APPENDIX 107W

UNITIZATION PROCEDURES FOR BOXED AMMUNITION AND COMPONENTS ON 4-WAY ENTRY PALLETS

SIGNAL, SMOKE AND ILLUMINATION, AIRCRAFT,
PACKED 4 PER WOODEN BOX, UNITIZED 12
BOXES PER 35" X 45½" PALLET; APPROX BOX
SIZE 18¼" L X 16¾" W X 23⅝" H

REVISION NO. 1, DATED OCTOBER 1987, CONSISTS OF:

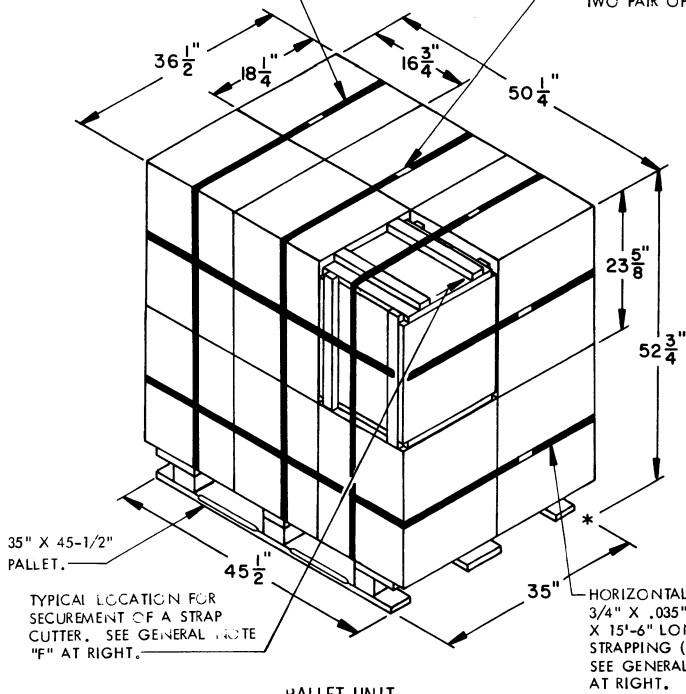
ADDING GENERAL NOTE "K".

- K. THE STYLE 1A PALLET DELINEATED IN THE DETAIL AT LEFT NEED NOT HAVE CHAMFERS OR STRAP SLOTS AS SPECIFIED WITHIN MILITARY SPECIFICATION MIL-P-15011 WHEN USED FOR THE UNITIZATION OF THE ITEMS COVERED BY THIS APPENDIX.
